8 Water quality

8.1 Chapter content

Gatcombe and Golding Cutting Channel Duplication Project

Figure 8.1 Impact to siltation rate near the Western Basin Expansion reclamation area due to the Project

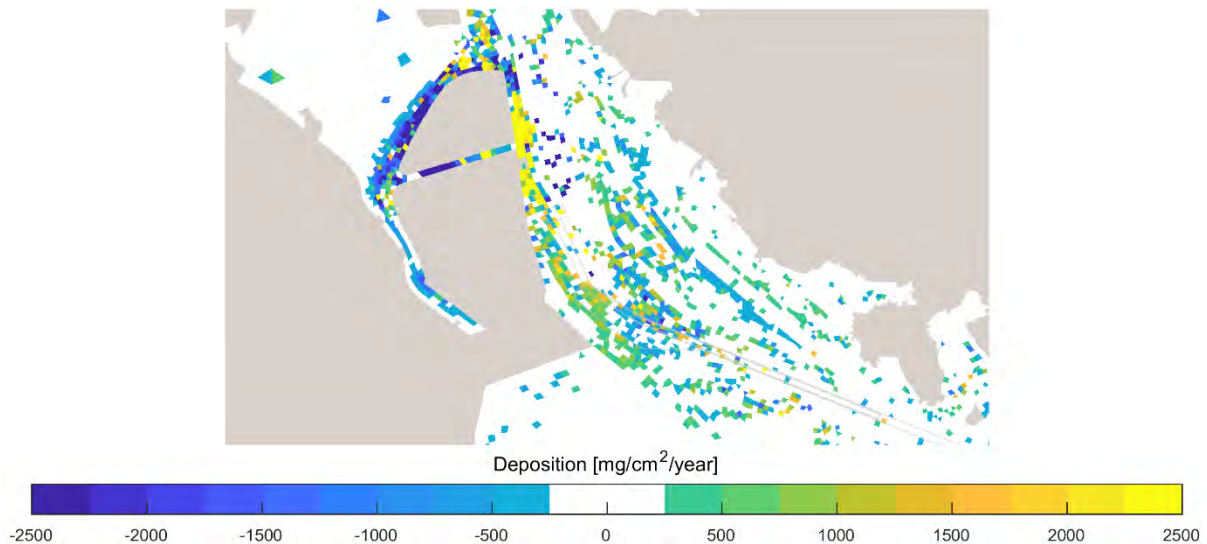
| Submitter ID number (refer Appendix B) | Summary of submission issue raised | Project EIS section (public notification version) | AEIS section containing information to address submission comments | Complete replacement section for Project EIS | Supplements the Project EIS information |
|--|--|--|--|--|---|
| 12.22 | Describe the likely future equilibrium depth of the channel to the north and west of the proposed WBE reclamation area as a result of increased flows and erosion in these areas | Section 8.6.4.2 (erosion and siltation subsection) | Section 8.2 | ✓ | |
| 12.23 | Provide an assessment of how increased sedimentation adjacent to the proposed WBE reclamation area would influence the requirement to undertake maintenance dredging of the northern section of the shipping channel | Section 8.6.4.2 (erosion and siltation subsection) | Section 8.2 | ✓ | |

Figure 8.1 illustrates the modelled change to the annual siltation/erosion rate for the Base Case and the Project Channel Geometry Case (i.e. the expected change in the siltation/erosion rate due to construction of the reclamation area). The model indicates the potential for some erosion in the channels surrounding the new reclamation areas. This erosion would continue (provided the bed material is erodible) until the channel reaches a new equilibrium depth. Note that this means that the predicted rates of erosion in the channels would not be sustained long term, since the bed morphology would adjust to the new regime and net erosion and accretion will trend towards zero as a new equilibrium profile is obtained.

Figure 8.1 also indicates that the siltation rate can be expected to increase to the east of the proposed WBE reclamation area, including part of the dredged channel in the vicinity of Fisherman's Landing (though not in swing basins and berth pockets adjacent to the liquified natural gas (LNG) facilities on Curtis Island). The model results indicate that an increase in maintenance dredging volume in the Fisherman's Landing area of approximately 11% could be expected (i.e. additional 3 days of maintenance dredging within the Port of Gladstone).

Figure 8.4: Baseline water quality monitoring locations

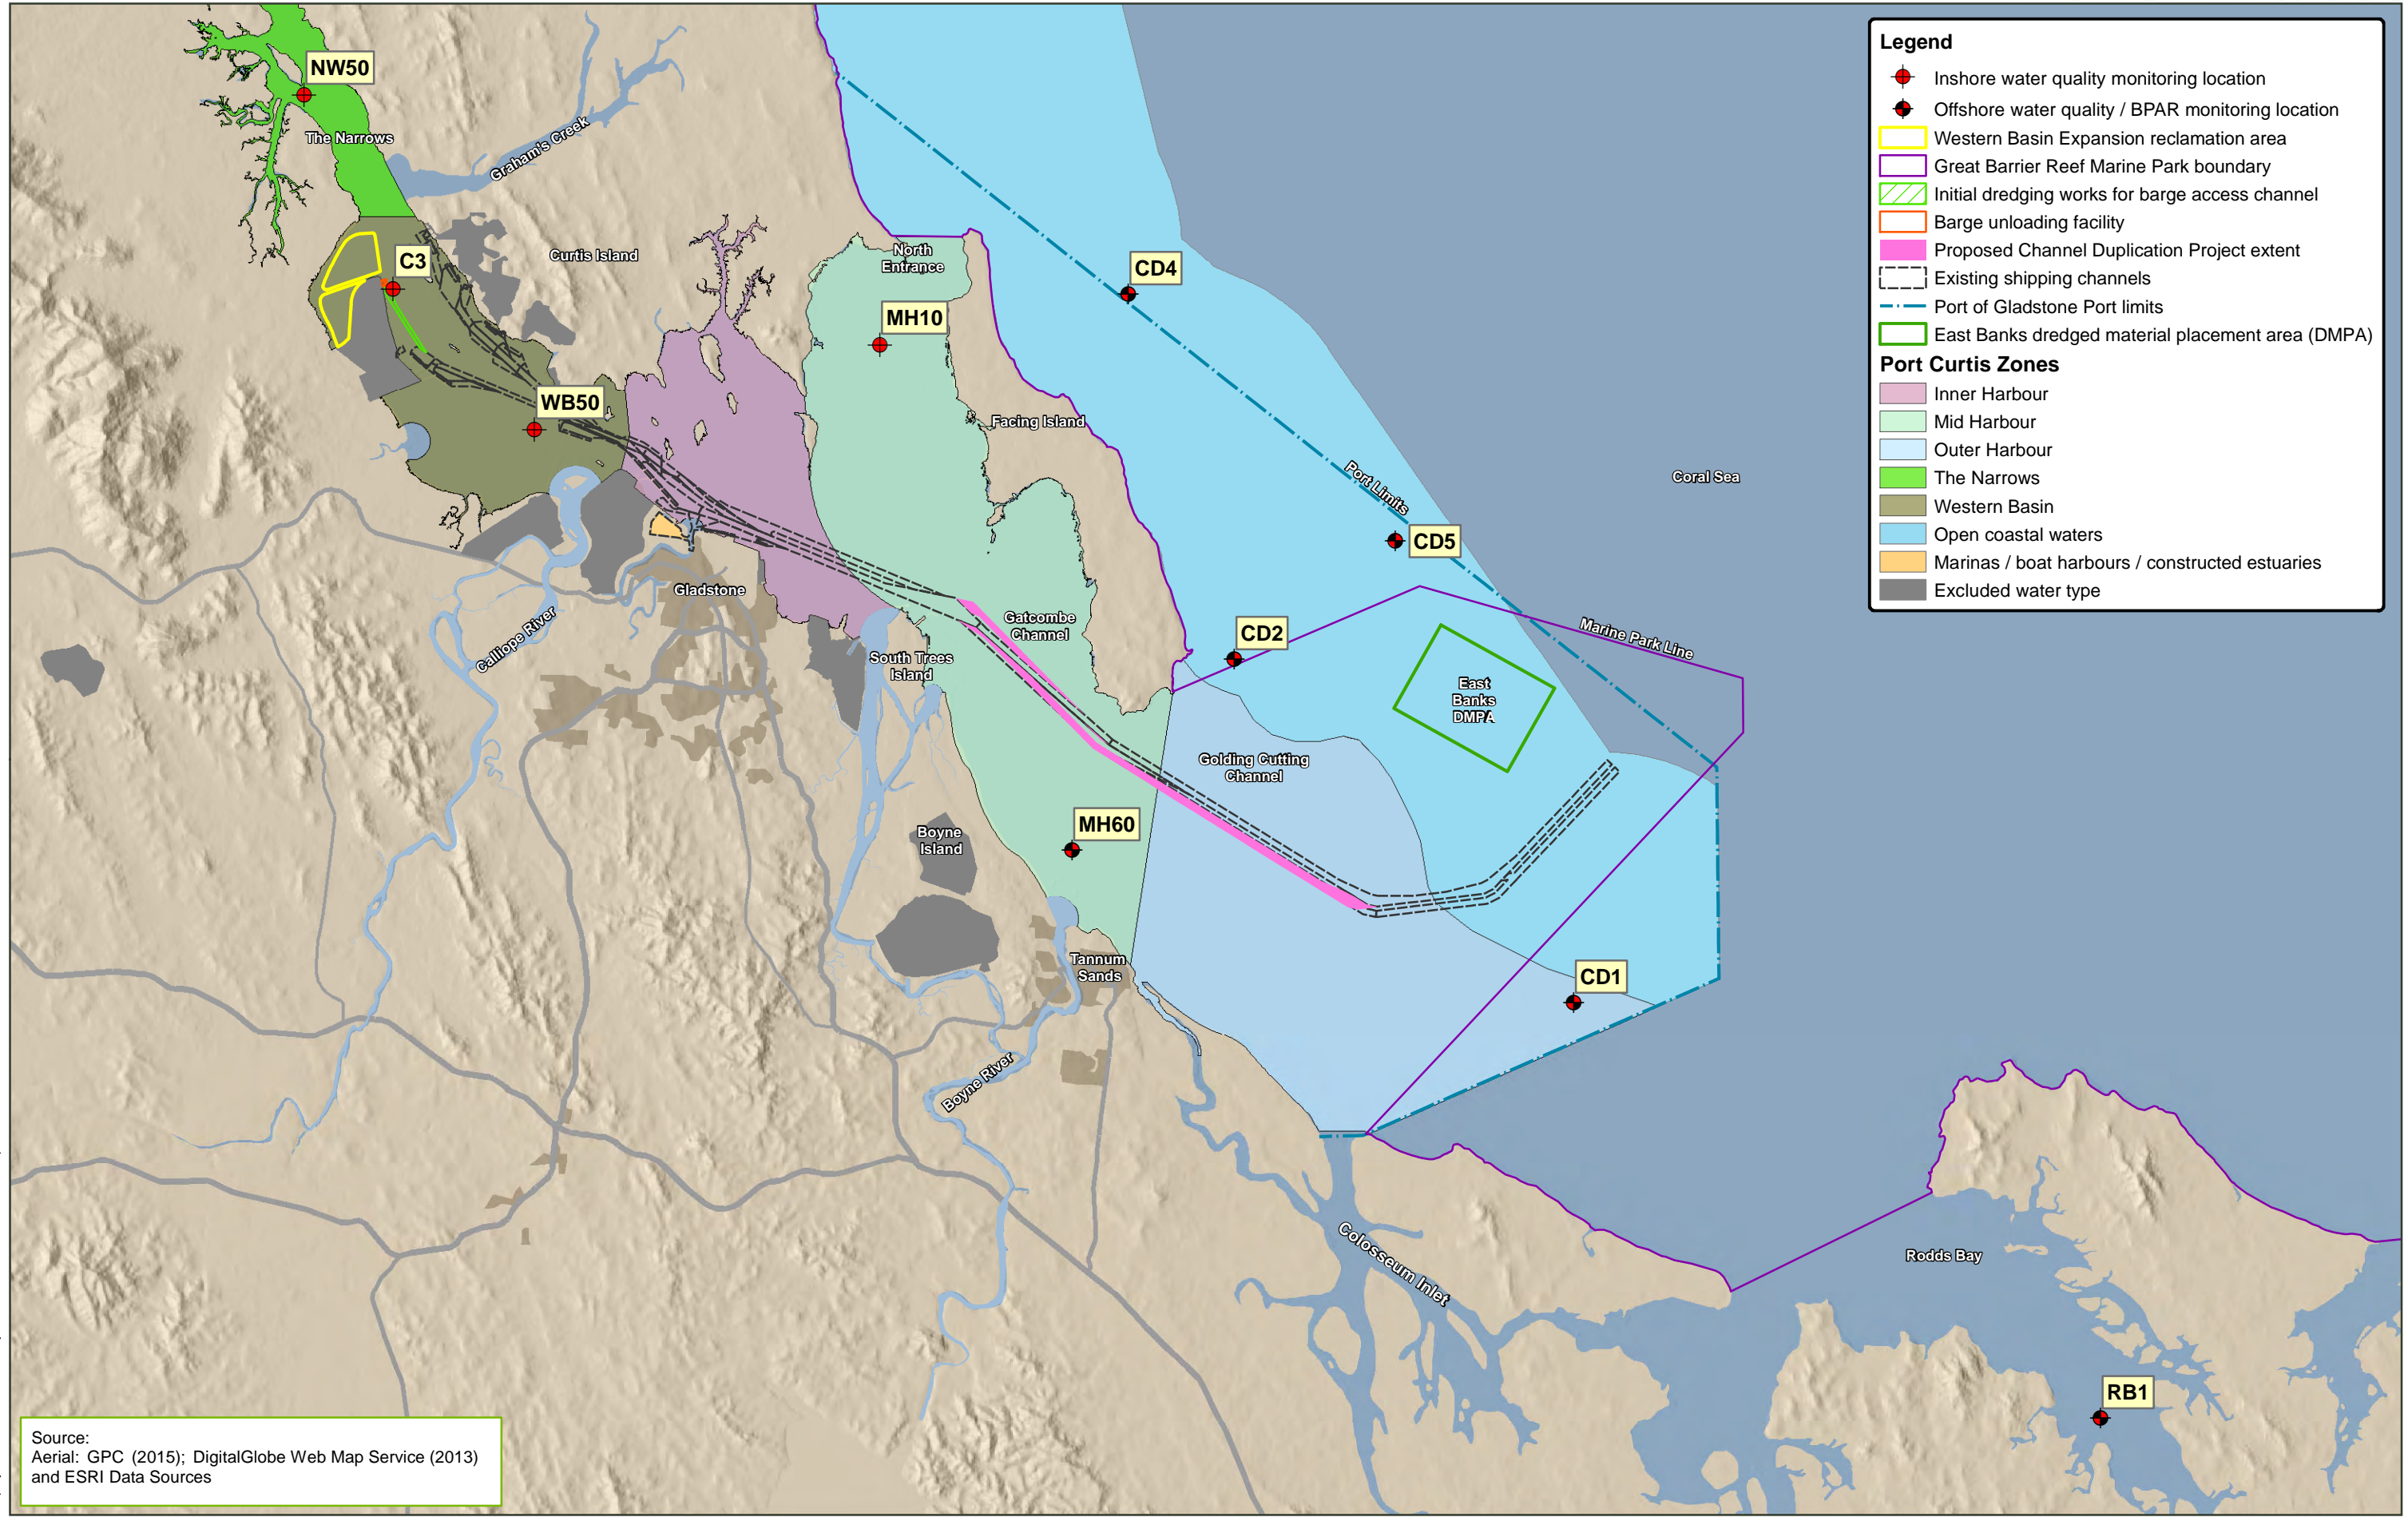
| Submitter ID number (refer Appendix B) | Summary of submission issue raised | Project EIS section (public notification version) | AEIS section containing information to address submission comments | Complete replacement section for Project EIS | Supplements the Project EIS information |
|--|--|---|--|--|---|
| 12.29 | Nominate appropriate water quality monitoring reference sites (i.e. for physicochemical parameters and toxicants) located outside the predicted zone of influence of dredging | Section 8.2.1.2 | Section 8.3.1 | | ✓ |
| 12.30 | Provide a table describing the naming of each site and its relation to historical water quality monitoring data, as well as monitoring methods proposed to be used in the future monitoring program. | Section 8.2.1.2 | Section 8.3.2.1 | | ✓ |
| 12.31 | Describe why the inshore sites are excluded from the compliance water quality monitoring program, or re-instate baseline monitoring sites (e.g. QE3, P5 and CD3) for inshore waters in the future project monitoring program (refer Section 6.1, Table 4 and Table 11). | Appendix Q3 (Section 6.1.2) | Section 8.3.2.1 | | ✓ |

The Project EIS Appendix Q3 (Environmental Monitoring Procedure) has been replaced with AEIS Appendix H which includes the addition of one Project reference water quality site at Rodds Bay (i.e. RB1 shown on Figure 8.4). This proposed reference water quality site has been monitored previously for the WBDDP. The Project water quality reference site will be monitored for water quality parameters as per the other Project water quality monitoring sites as detailed in the Project Environmental Monitoring Procedure (refer AEIS Appendix H).

The relationship between the Project EIS baseline water quality sampling data for CD3, P5/MH10, P2B/WB50 and QE3, and the compliance water quality sites MH60, MH10, WB50 and NW50 shown in the Project Environmental Monitoring Procedure, respectively, are the same sites spatially, with the only change being the naming convention of the sites.

Figure 8.5 Zones of impact for the overall Project dredging activities

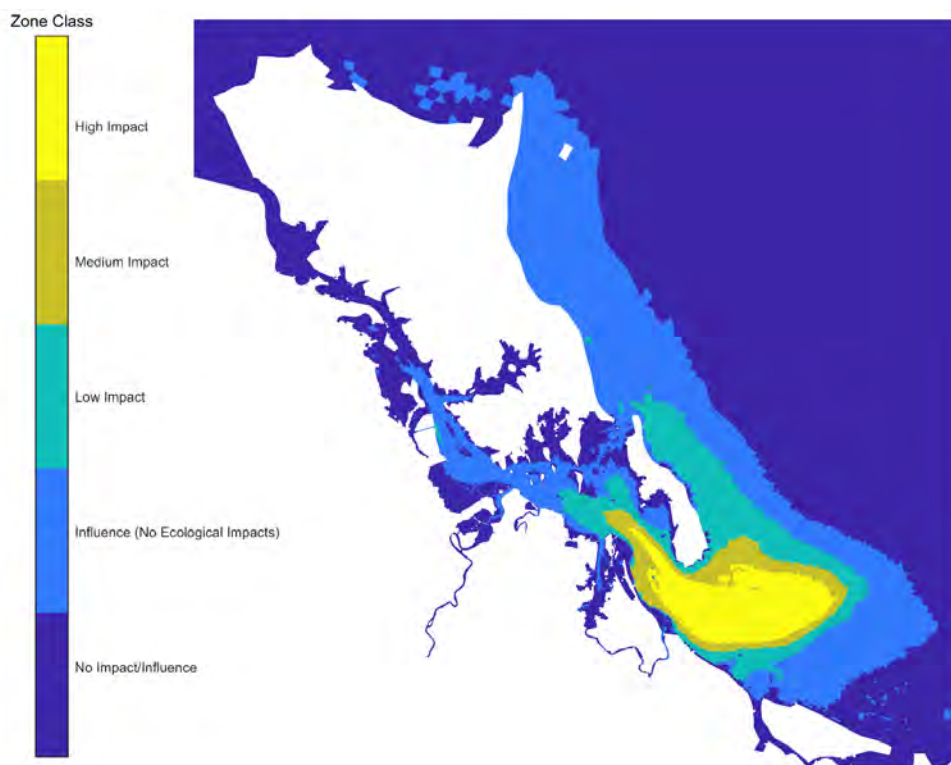
| Submitter ID number (refer Appendix B) | Summary of submission issue raised | Project EIS section (public notification version) | AEIS section containing information to address submission comments | Complete replacement section for Project EIS | Supplements the Project EIS information |
|--|--|---|--|--|---|
| 12.27 | Describe why the project cannot achieve the industry best practice limit of 50mg/L and why this project should be licensed to discharge at the higher 100mg/L. This information should include evidence that this increased discharge limit will not impact environmental values | Section 9.13 | Section 8.3.3 | | ✓ |

- The predicted Project zone of impact from the Project initial dredging works is shown to be low impact within the barge access channel, while the licenced discharge from the existing Western Basin reclamation area is shown as the zone of influence for marine waters between the reclamation areas and Curtis Island (refer Figure 8.5). The zone of influence represents the predicted full extent of detectable plume, but no ecological impacts will occur.

The Project EIS and AEIS, and the implementation of the Dredging EMP and Environmental Monitoring Procedure (refer AEIS Appendices F and H) have demonstrated that the modelled licenced discharge of 100mg/L is appropriate for the maintenance of water quality and sensitive ecological receptors within the Port of Gladstone. The AEIS has amended the Environmental Monitoring Procedure to include an additional water quality monitoring site (C3) in the vicinity of the existing Western Basin reclamation area (refer Figure 8.4) which will further assist in minimising the potential impacts from the Project tailwater licenced discharges by implementing the adaptive management measures included in the Procedure.
